PRODUCT BULLETIN

Product(s):	Fabius GS
Bulletin Number:	156
Release Date:	October 27, 2003
Pages:	1

Subject: Modification to Ventilator Hose-Moisture Reduction Kit

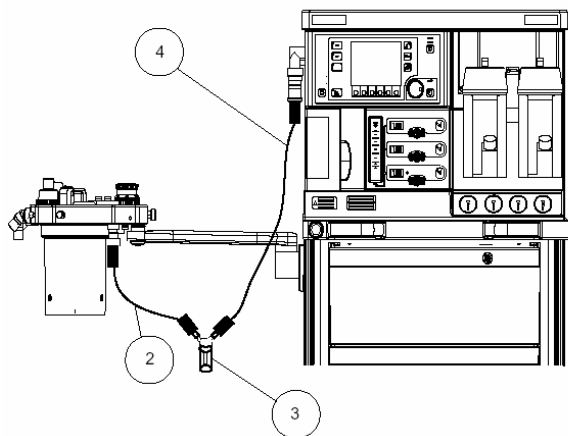
In order to provide additional flexibility in positioning the height of the watertrap, two different hose lengths are now included as part of the Moisture Reduction Kit. One hose, either 25cm or 35cm, can be used in position 2 shown in the diagram below. Selection of the hose length will depend upon the desired height at which the watertrap is to be located. To ensure optimal effectiveness, the watertrap should be located at the lowest point between the vent hoses. The addition of the second hose length should reduce the need for repositioning the Coby height to optimize the watertrap height.
